COTTER CORPORATION (N.S.L.)  
RESPONSE TO  
COLORADO DIVISION OF RECLAMATION, MINING AND SAFETY  
ADEQUACY REVIEWS  
OF  
SCHWARTZWALDER MINE, PERMIT NO. M-1977-300  
AMENDMENT 4 (AM-04)  
SUBMITTED TO DRMS  
APRIL 5, 2013

April 5, 2013

Figure 1 - Revised Schwartzwalder Dewatering and Treatment Schedule

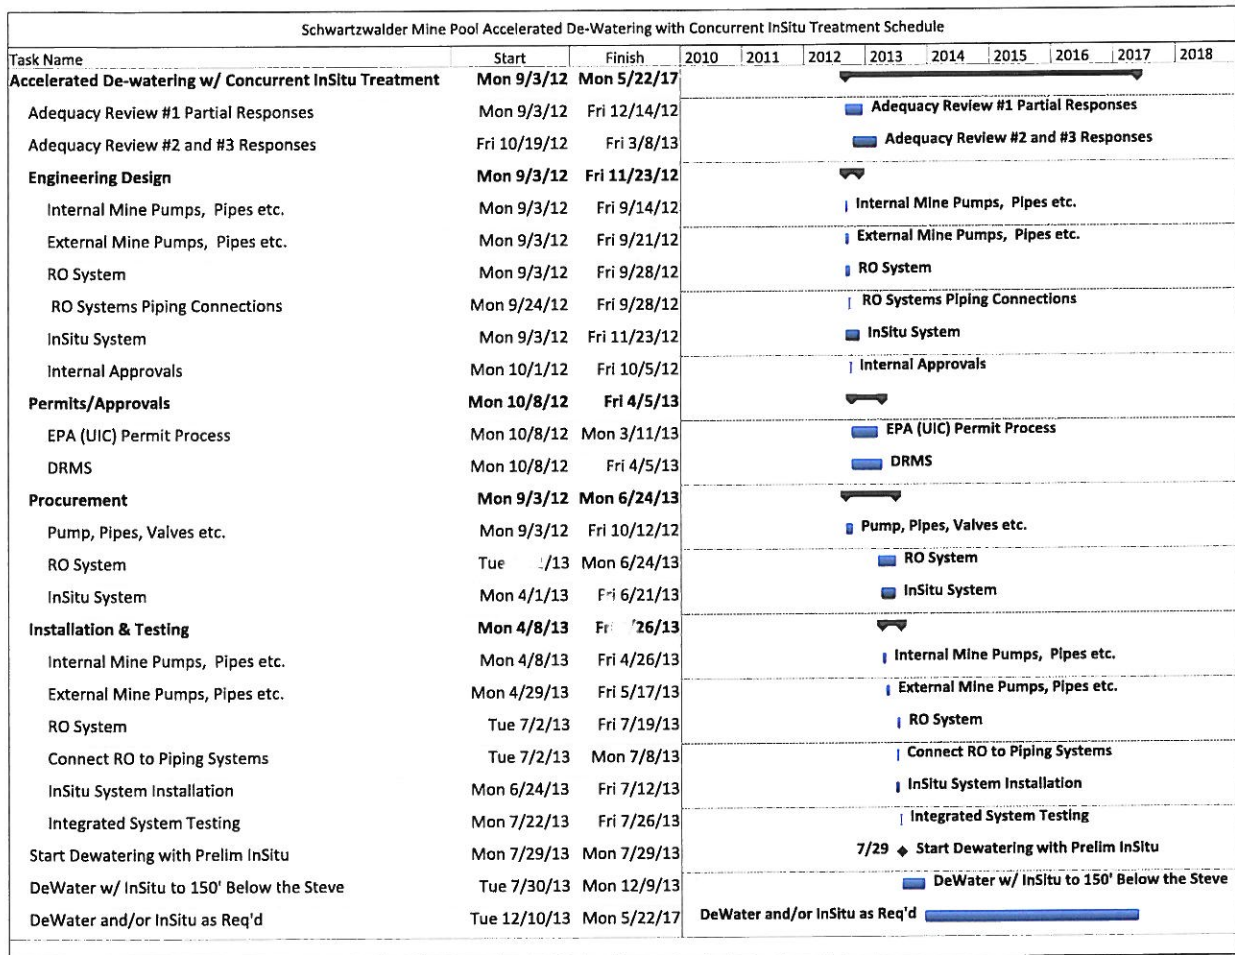
*2. Please revise Figure 18 of Exhibit E to provide for concurrent initiation of mine pool pumping and in-situ treatment.*

The revised schedule is shown in Figure 1.

Table 1. Constituents to be Analyzed Monthly

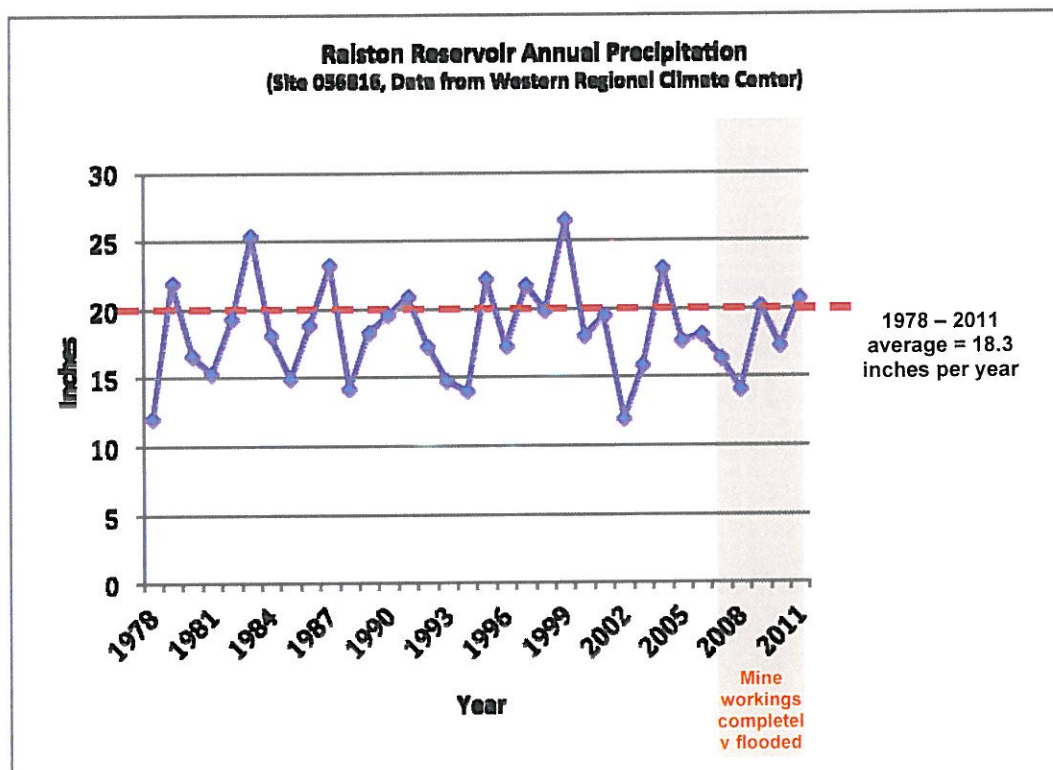
*6. Please add to Exhibit E the minimum criteria that must be met before the in-situ trial is terminated and full-scale in-situ treatment begins.*

In-situ treatment of the mine pool will occur in two stages, the first being the addition of a heavy organic carbon source into the mine as part of the backfill slurry during initial dewatering, which is expected to take up to four months. During this initial dewatering, mine pool conductivity, oxidation/reduction potential (ORP), pH, and temperature will be monitored continuously. Additionally, the constituents in the chart below will be analyzed on a monthly basis to supplement Cotter's current quarterly mine pool analysis, which shall continue to be performed. If beneficial effects from the initial addition of the heavy carbon source are confirmed, Cotter will proceed with full-scale in-situ treatment of the mine pool at a level at least 150 feet below the Steve level.

Figure 2 - Revised Figure 7 of Exhibit E

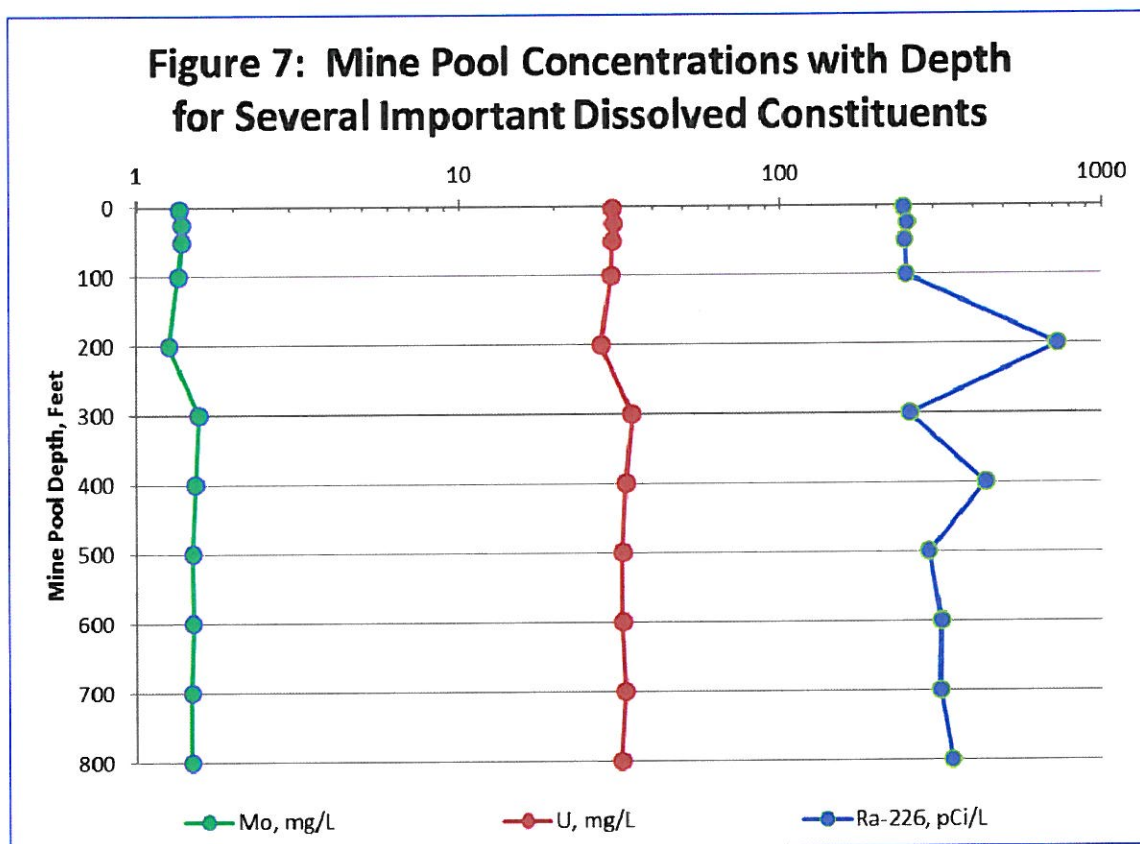
23. Please revise Figure 7 to show radium in picocuries per liter (pCi/L).

Figure 3 - Isometric View from Southeast showing Glory Hole, Mine Workings and Major Fault Planes

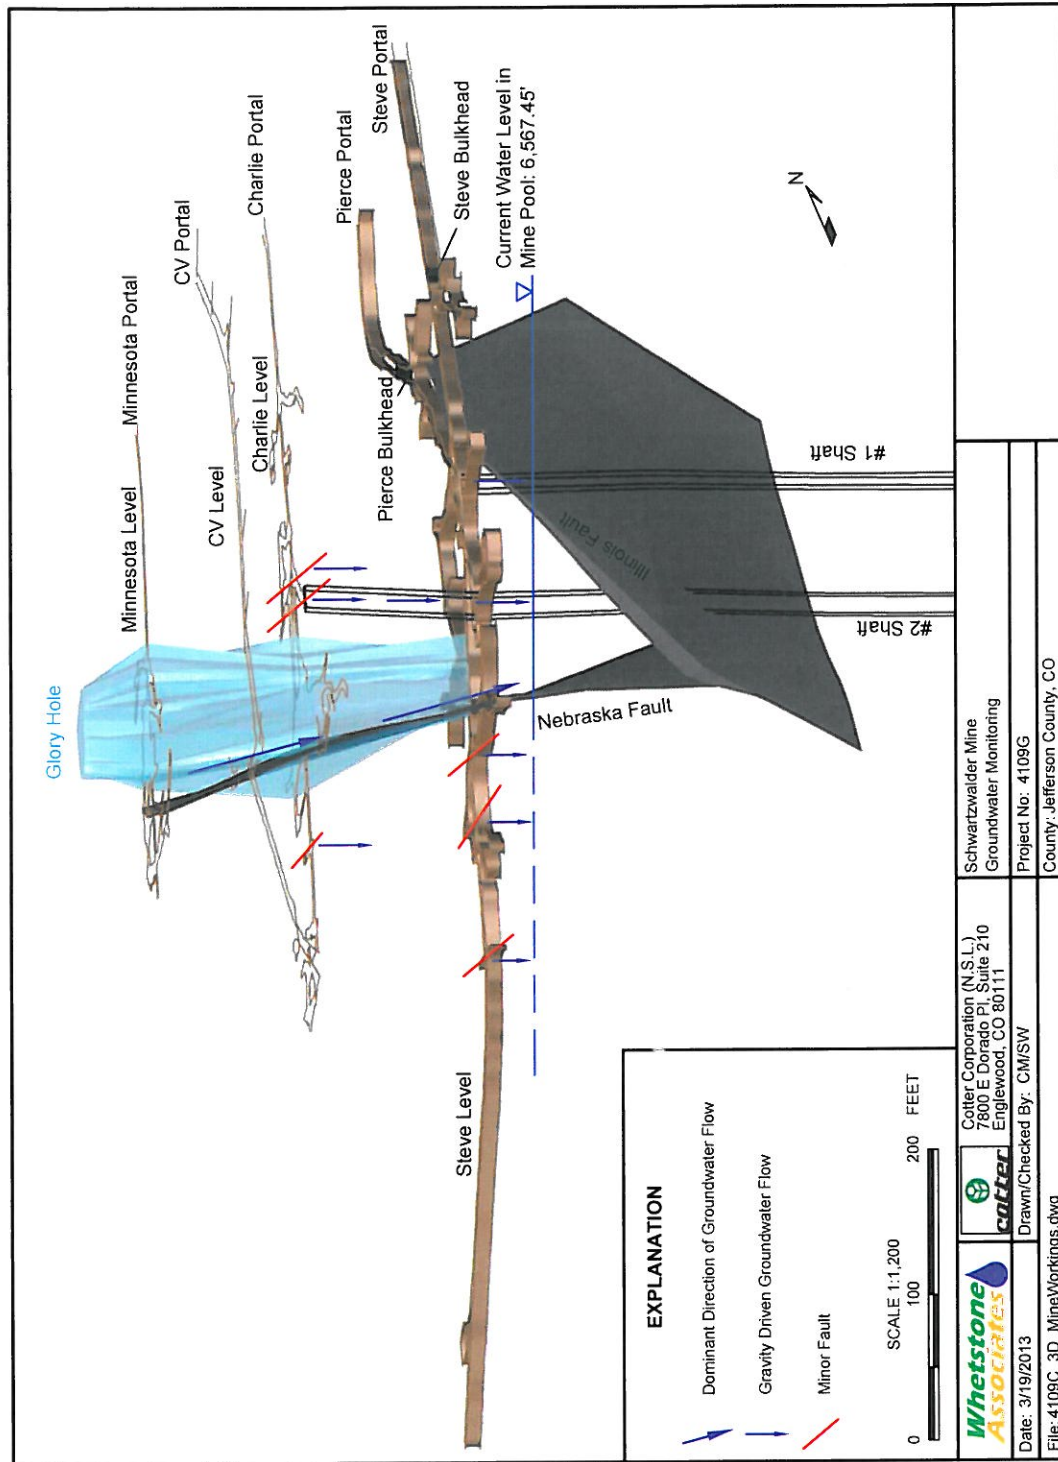
24. Please add to Exhibit E a detailed drawing showing the precise flow path of naturally seeping ground water at the base of the Glory Hole as the water reports "to the adjacent mine pool" (page 19 of Exhibit E). Without properly designed backfilling and drainage, the flow of the

*seeping water at the base of the backfilled area could be blocked as the fill settles, resulting in much of the fill becoming saturated with the seeping water.*

*A seepage rate of 1 gpm in the Glory Hole would be sufficient to saturate the entire 56,000 cubic yards of backfilled alluvial fill in less than 2 years (assuming the fill has 15% porosity). Alluvial material is proposed to be backfilled in the Glory Hole to a height greater than 150 feet. If this material becomes saturated it could exert more than 150 feet of head on the hydraulic seal in the Steve Level at the base of the fill and exceed the seal's designed maximum pressure of 120 feet of head.*

A three-dimensional drawing showing the flow path of groundwater from the Glory Hole to the mine pool is shown in Figure 3 attached to this document. The Glory Hole was mined out along the Nebraska vein, Colorado vein, Kansas vein, and the Flat vein as shown in Figure 4 attached to this document. Within the Glory Hole, any infiltrating groundwater percolates downward vertically toward the underlying mine pool as shown by the blue arrows in Figure 3. Because flow is driven by gravity, the vertical component of flow is dominant. In some cases, the vertical flow may have an angular component, as water seeps down the excavated face of the underground workings (Figure 3).

Figure 6 - Replacement Page for Exhibit E Figure 21

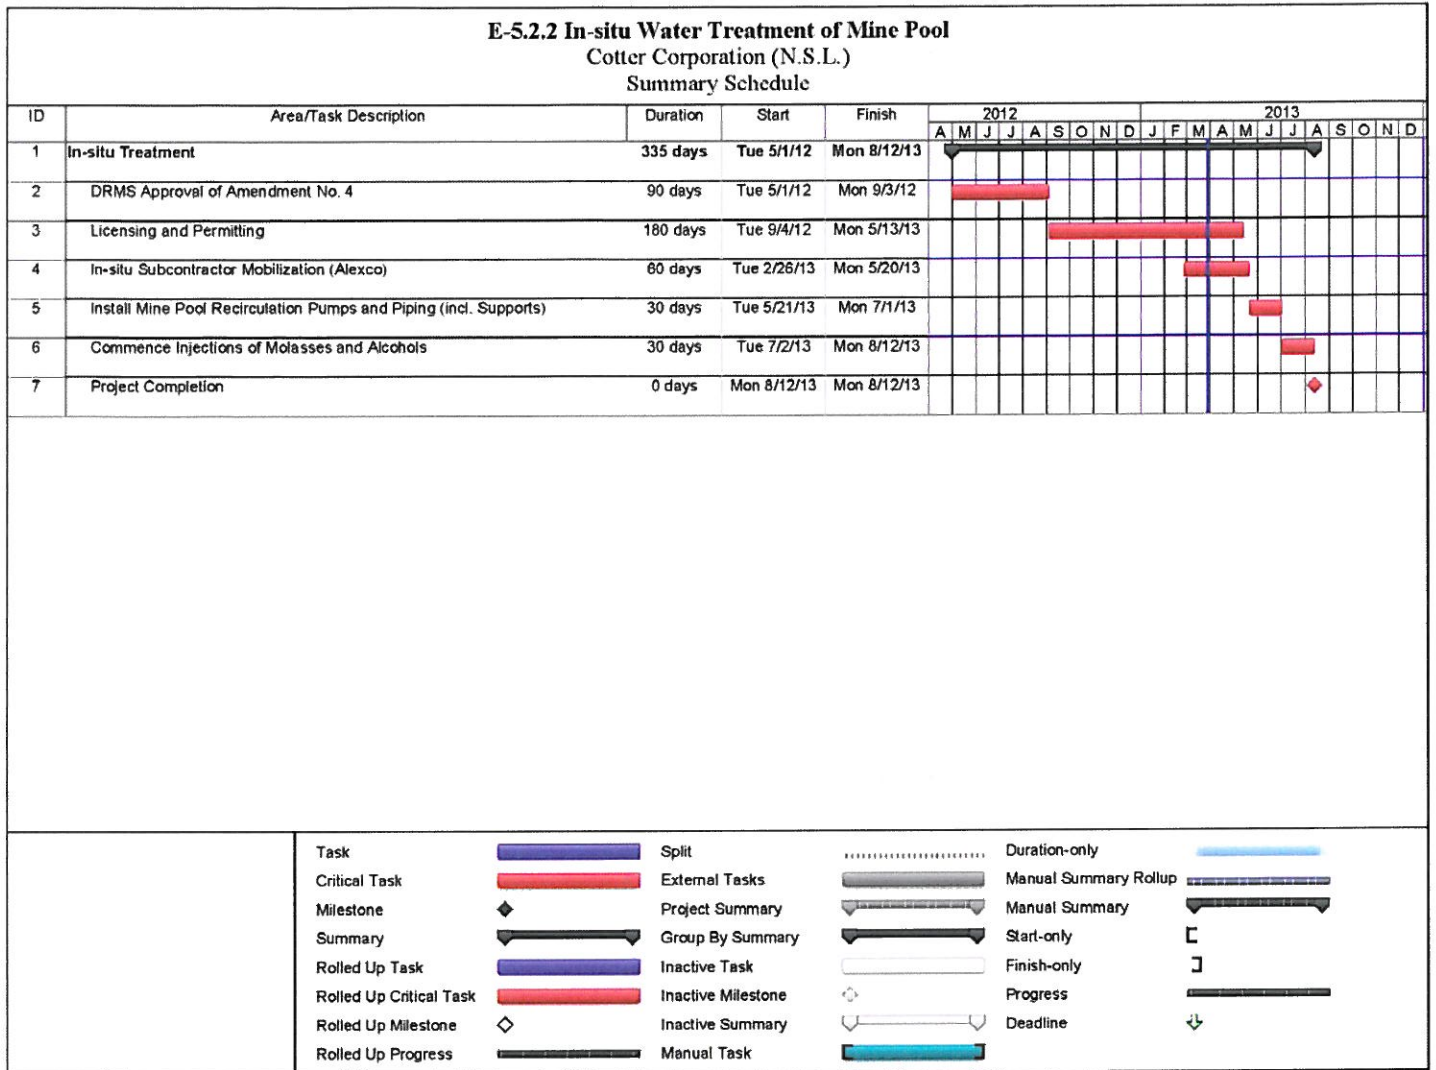
*14. Please provide legible replacement pages for Figures 8 and 21 of Exhibit E.*

Please see the attached Figure 5 and Figure 6; replacement pages for Exhibit E Figures 8 and 21 respectively.
